EL SEGUNDO POWER REDEVELOPMENT PROJECT

**Dry Cooling Amendment (00-AFC-14C)
Los Angeles County**

STAFF ANALYSIS ADDENDUM I

**Response To Comments On
The Staff Analysis Published June 12, 2008**

LAND USE - FIGURE 5

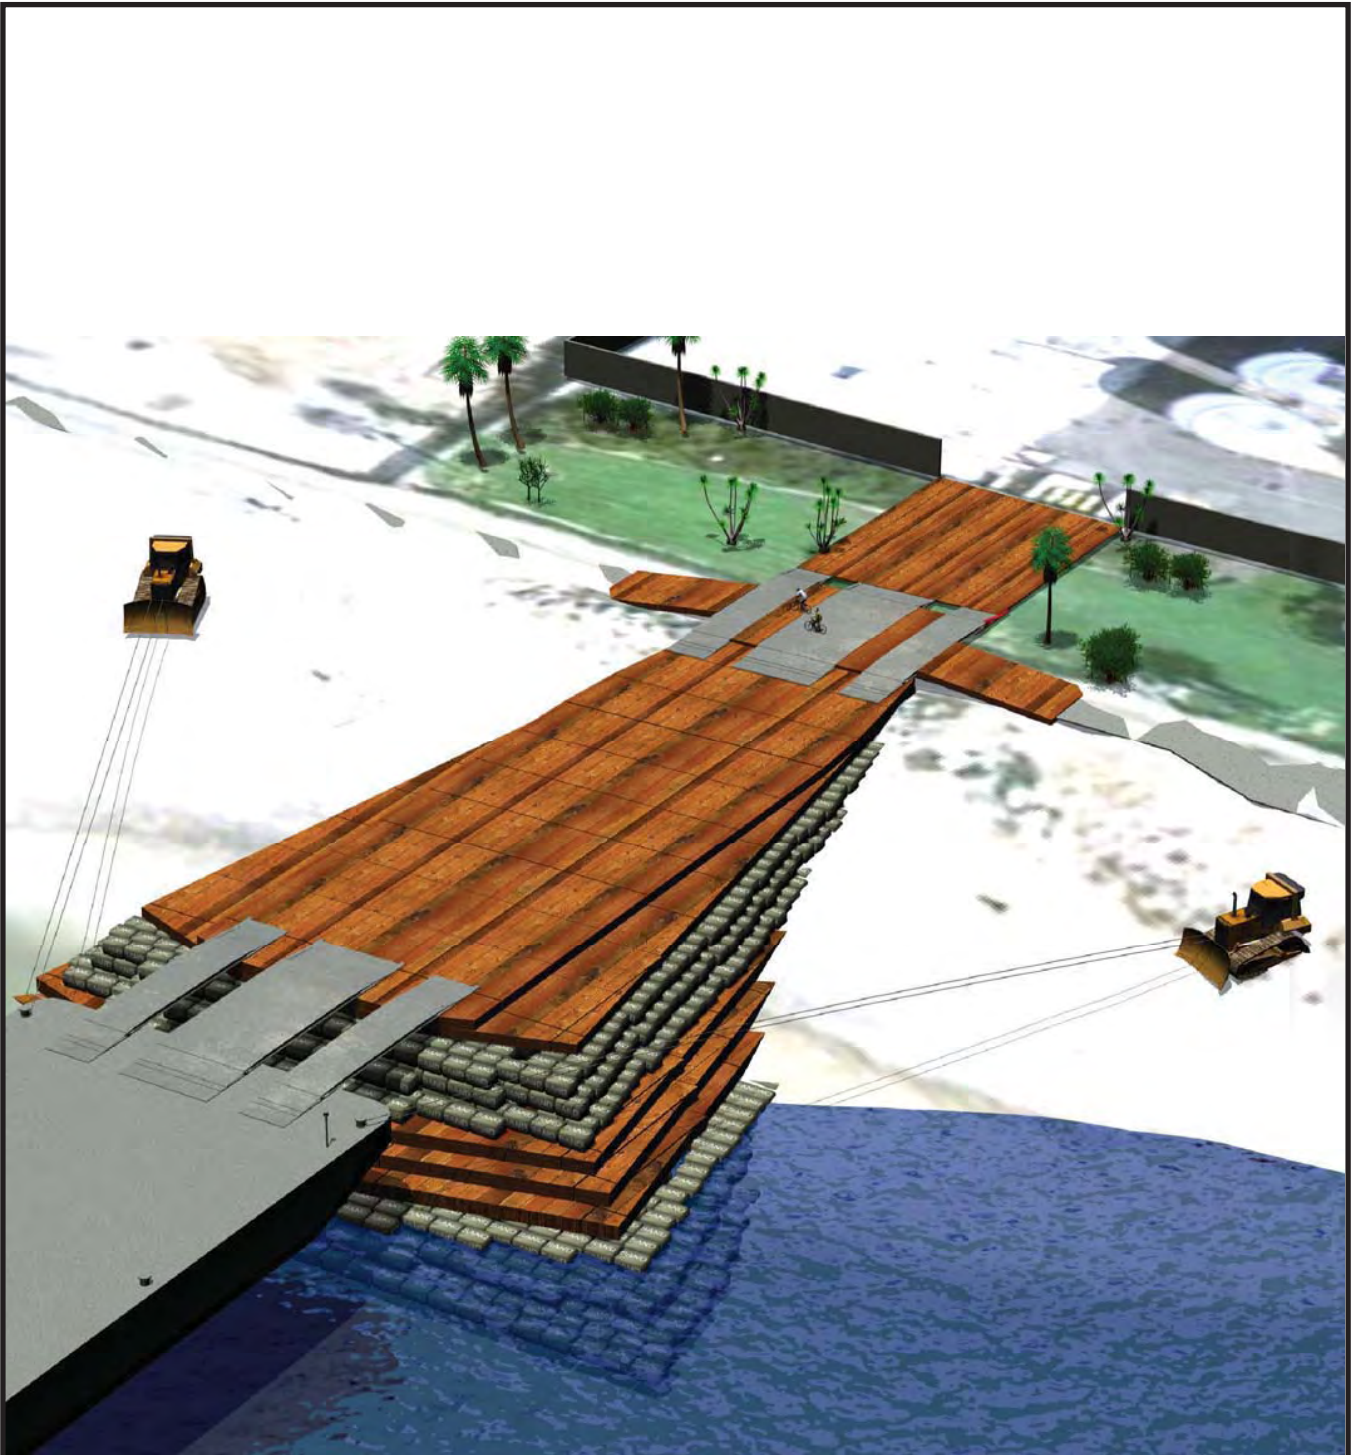
In Condition of Certification **LAND-13** and the **LAND-13** Verification section, the project owner has requested insertion of the phrase, “or equivalent land use document,” to provide the opportunity for a document other than an executed lease with the California State Lands Commission be considered acceptable proof that the State Lands Commission has approved the use of the beach area to be used for the beach delivery of equipment if the beach option for equipment delivery is, in fact, selected.

During the beach delivery phase, beach users would not be able to use an approximate 300-foot by 300-foot (2 acres) beach area west of the El Segundo Generating Station between Dockweiler State Beach and Manhattan Beach (**Land Use Figure 3 – Beach Area West of the El Segundo Generating Station**). This beach area, owned by the project owner, is to be traversed by an approximate 250-foot long beach ramp made of geo-tech fiber, wood matting and sandbags with an access ramp extending over the bicycle trail into the El Segundo Generating Station. The access ramp would include closure gates across the bike path to prevent public access to the beach ramp during deliveries. Fencing for safety and security purposes would be installed around the beach delivery area (**Land Use Figure 4 – Conceptual Layout of Beach Delivery Area**). **The project's proposed ramp crossing the beach to move oversized equipment from barges docked in Santa Monica Bay to the project site may affect beach operations conducted by the LACDBH (Land Use Figure 5 – Beach Ramp Rendering).**

Modified Conditions of Certification and Revised Figures 5 and 6:
